Service Bulletin No. 277

MODEL D4500 / D4505 Series Coaches	TYPE Field Change Program	SECTION/GROUP 12--Suspension	DATE Dec. 22, 2006
SUBJECT FIXED TAG SUSPENSION MODIFICATION			
CONDITIONS CUSA D4500 / D4505 Series Coaches

Ref. NHTSA Recall No.: 06V--480

Figure 1.

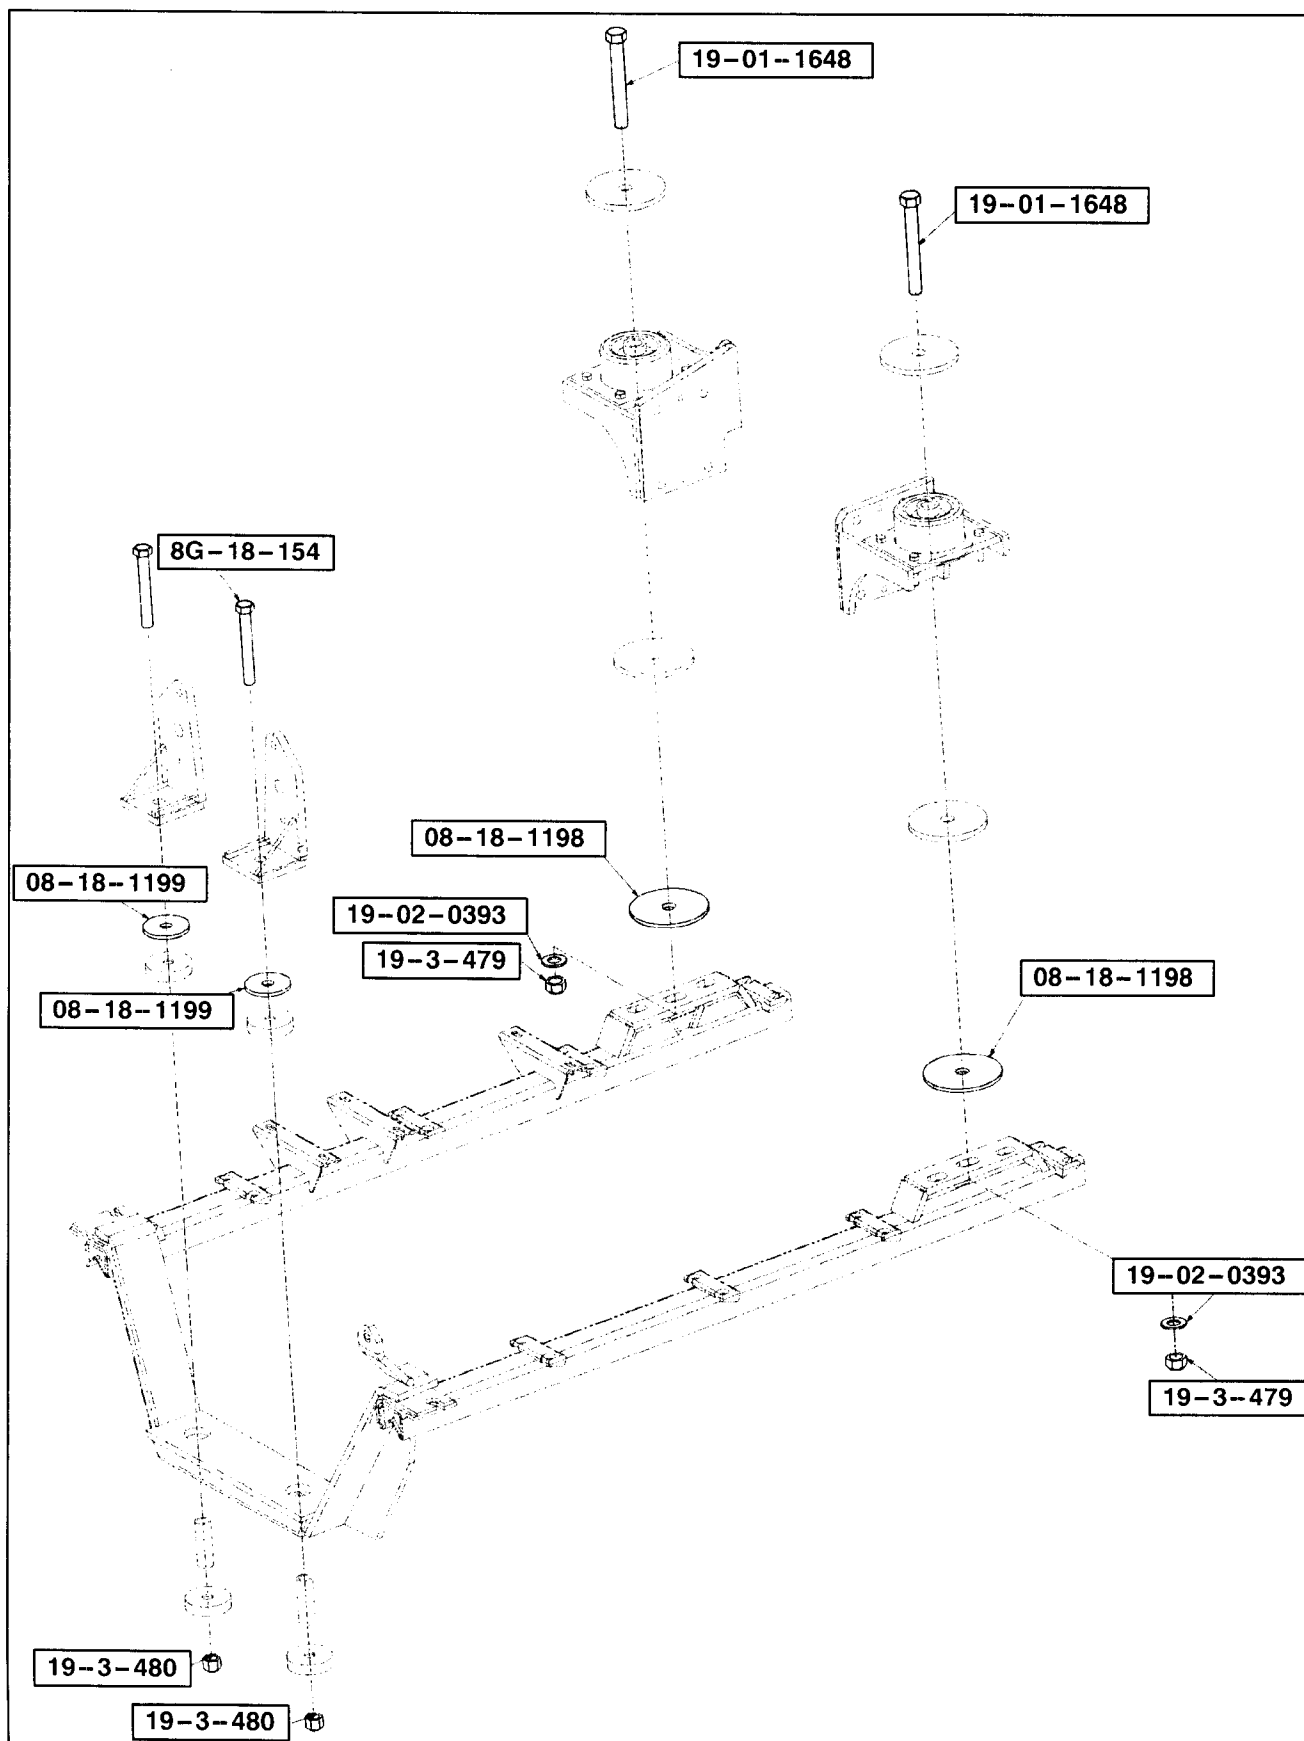
1. Turn the main battery disconnect switch to the “ OFF “ position. Chock both sides of the tires.
2. Open the engine compartment doors. Locate the engine remote and position the ENGINE RUN and ENGINE START to the OFF position.
3. Locate the engine cradle mounting hardware shown in Figure 1 (four locations).
4. Remove and discard the existing locknuts only from the four locations shown in Figure 1.

7. Remove and discard the existing fastener (and washer if applicable). Install appropriate shim (p/n 08-18-1198 or 08-18-1199) and new mounting hardware provided in Parts list. Tighten nut hand tight only.
8. Repeat Step 7. to next fastener.

9. Upon completion of installing the four shims and mounting hardware, lower the jack removing all stress from the engine. Remove the jack from under the coach.
10. Torque 19-3-480 to 285–385 lbs.-ft. Torque 19-3-479 to 451 –546 lbs.-ft.

Figure 3. Reference photo.

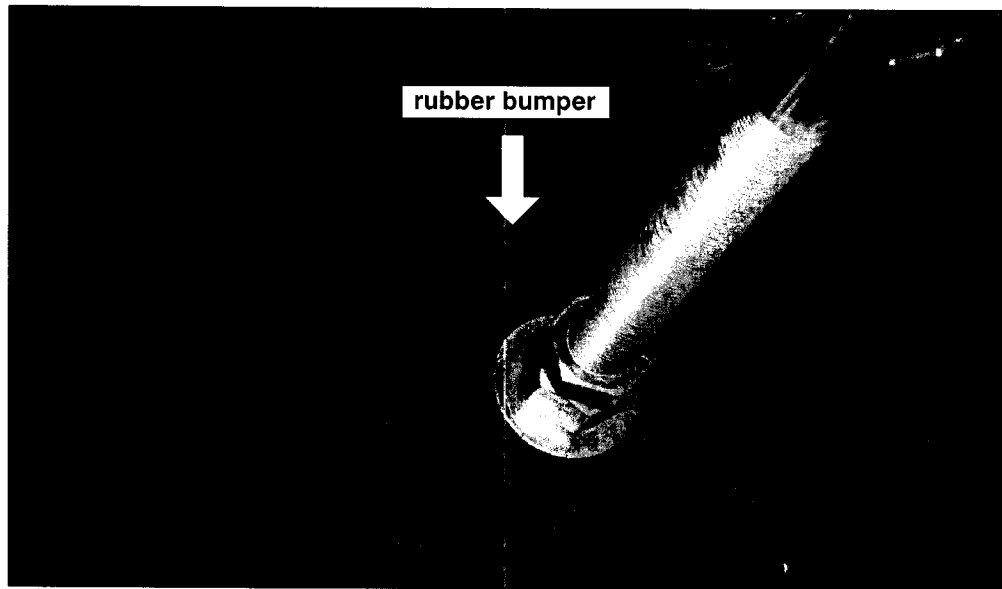
11. Locate the four existing rubber bumpers on the tag axle suspension assembly (Figures 3 and 5).

12. Remove existing bumper assembly and discard. DO NOT re-use existing bumper.

13. Disk sand the mounting surface in preparation of good reassembly.
14. Install the new rubber bumper (p/n 12G-1-5) and bumper block spacer (p/n 12G-1-6) (Detail B / Figure 5).

Figure 4.

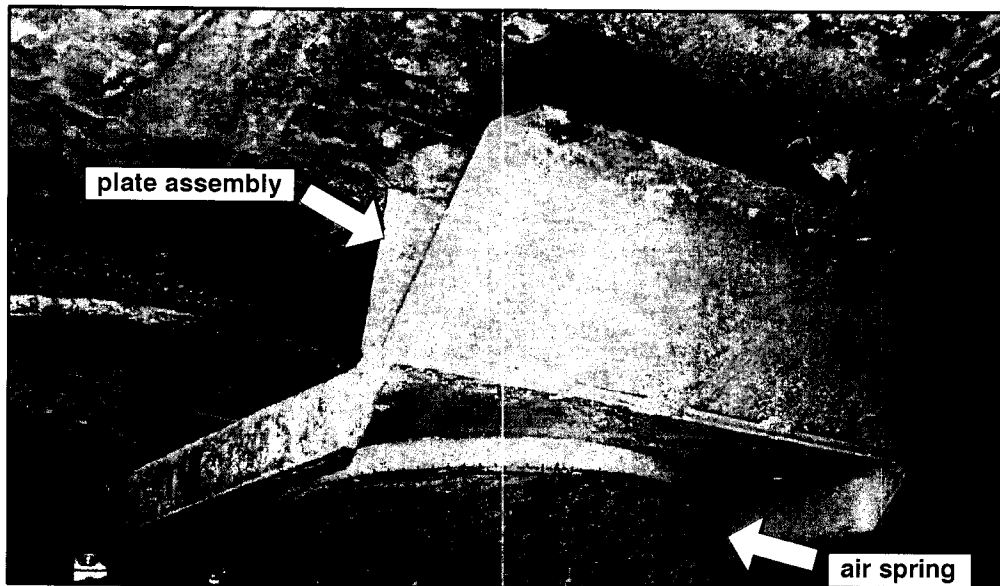
15. Remove and discard the plate assembly and mounting hardware (Figures 4 and 5).
